ID0000175  
Response to Comments  
Hecla  
Lucky Friday Mine

EPA, Region 10  
June 2019

Prepared by:  
Cindi Godsey, EPA

**BLM-based Criteria Comparison**

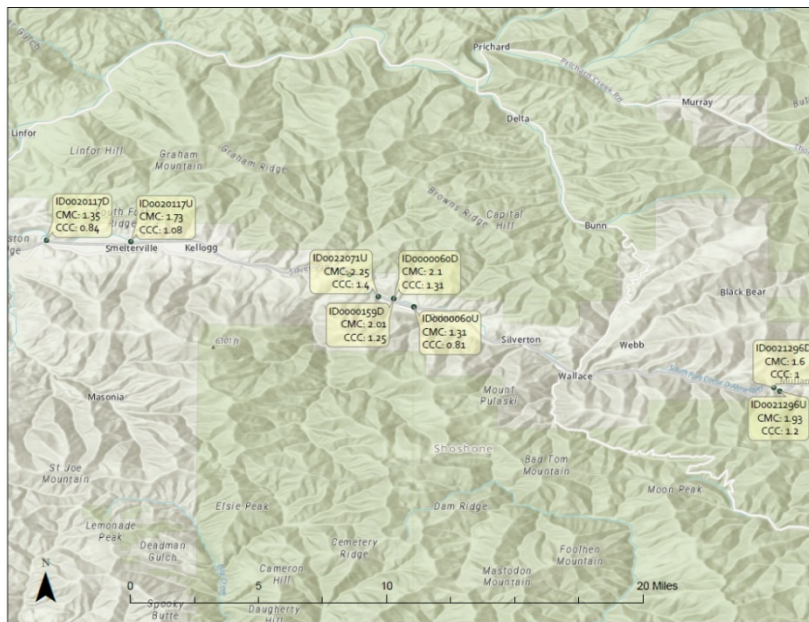
4. **Comment:** Part I.B (page 4): LFU has concerns with the approach for calculating the copper BLM based effluent limits, as presented in the Draft Permit and Fact Sheet. LFU understands the BLM-based copper effluent limits were developed using a regional classification system, as described in Statewide Monitoring for Inputs to the Copper Biotic Ligand Model (2017). However, LFU has the following concerns with the approach:

- The Mountain Stream class criteria are overly conservative for the SFCdAR near LFU. The Draft Fact sheet (pg. 71) notes that background concentrations of Cu are higher than the BLM criteria, with the average dissolved copper concentration of 1.21 ug/L above Outfall 002 and 0.69 ug/L above Outfall 003 over the monitoring period from 2012-2016. However, 10 years of site-specific bioassessment data show stream aquatic community equal to regional reference streams, indicating the Mountain Stream criteria are likely overly conservative. Based on the above discussion, LFU requests that the approach to use default regional input values for calculating the copper BLM-based effluent limits be reconsidered. LFU requests that the hardness-based copper effluent limits remain effective until after adequate site-specific data can be collected and site specific BLM criteria can be calculated during the five year compliance schedule period. Additionally, as per the Implementation Guidance for the Idaho Copper Criteria for Aquatic Life (2017), flow-tiered NPDES permit limitations are an acceptable implementation tool for copper Biotic Ligand Model (BLM)-based limits. Due to the extremely low BLM-based criteria and potential variability of BLM input parameters, LFU requests that flow-tiered limits be considered when defensible site-specific BLM based effluent limits are established in the Permit.

**Response:** The Fact Sheet specified that the BLM based effluent limitations would only be included in the final permit if EPA approved DEQ’s submission of the new WQS prior to EPA finalizing the permit. This approval occurred on May 2, 2019. Therefore, the applicable WQS in place for CWA purposes is the copper BLM WQS. The Fact Sheet also stated that since the ambient background concentration of copper exceeded the BLM criteria, no mixing zone could be authorized for copper.

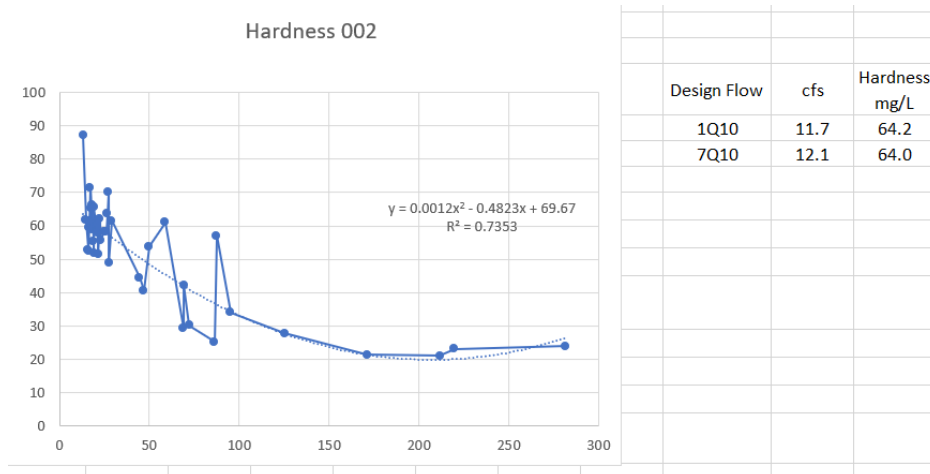
35. **Comment:** Please explain why EPA declined to analyze the full record of monitoring data for receiving water quality, outfall flow rate, effluent characterization, and critical low flow. EPA's Fact Sheet indicates the following analyses were based off varying date ranges of monitoring data Hecla collected pursuant to its current NPDES permit:

Hecla's current NPDES permit was issued in 2003. So, EPA has the benefit of well over a decade of monitoring data that should inform the development of Hecla's updated permit. For example, analyzing another year's worth of data (or more) could change EPA's calculation of the 99th percentile outfall flow rate. Similarly, another year's worth of data (or more) could reveal higher or lower potential maximum and minimum constituent levels in Hecla's effluent. And, changes to either or both of these variables could significantly affect EPA's determination of effluent limits and monitoring requirements. But rather than analyze all the data, EPA chose to limit its analysis to 4 years of data in some cases, without providing a reasonable basis for this decision.

We request EPA re-analyze receiving water quality, outfall flow rate, effluent characterization, and critical low flow based on the complete record of Hecla's monitoring data recorded since its current permit became effective.

**Response:** It is true that EPA did not utilize all the data from the latest permit term for the four categories listed above but there are valid reasons why this occurred. As the Fact Sheet contained the justification for several including the use of effluent data and outfall flow only since 2013 since the facility installed treatment just prior to a shutdown in 2012. EPA agreed with LFU that the data during 2012 may not be representative of the current operations and used only data after that point. Critical flows are based on 10 years (a 1Q10 being the lowest flow in a 10 year period while a 7Q10 is the lowest running 7 day average flow during a 10 year period) so using the most recent 10 years (at the time the Fact Sheet was being developed) is reasonable. As for receiving water quality, that information was required to be submitted on an annual basis and EPA did not have anything more current at the time that the Fact Sheet was being developed.

**Requested MDLs for Select Parameters**

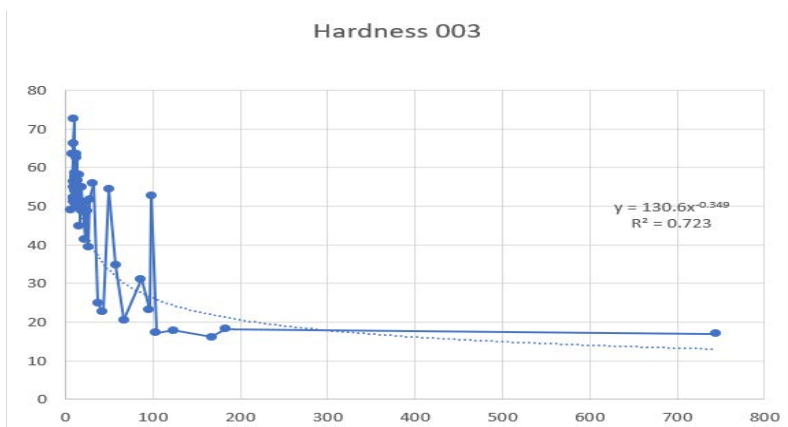
47. **Comment:** Part VI.C.4. (page 32): Table 16 of the Draft Fact Sheet provides the required MDLs for surface water monitoring. After consultation with their contract laboratory LFU has determined that the MDLs for calcium, magnesium and sodium provided in Table 16, are not attainable. Therefore, LFU requests the following MDLs be substituted for those provided in Table 16:

**Response:** EPA consulted the DEQ BLM Guidance for the required detection values necessary to determine site-specific BLM criteria since monitoring for several parameters is included specifically for criteria development. The BLM Guidance includes Reporting Limits and, these are comparable to a Minimum Level rather than an MDL. EPA has revised Table 5 in the final permit to contain a column of Reporting Limits for the parameters necessary to derive the BLM criteria.
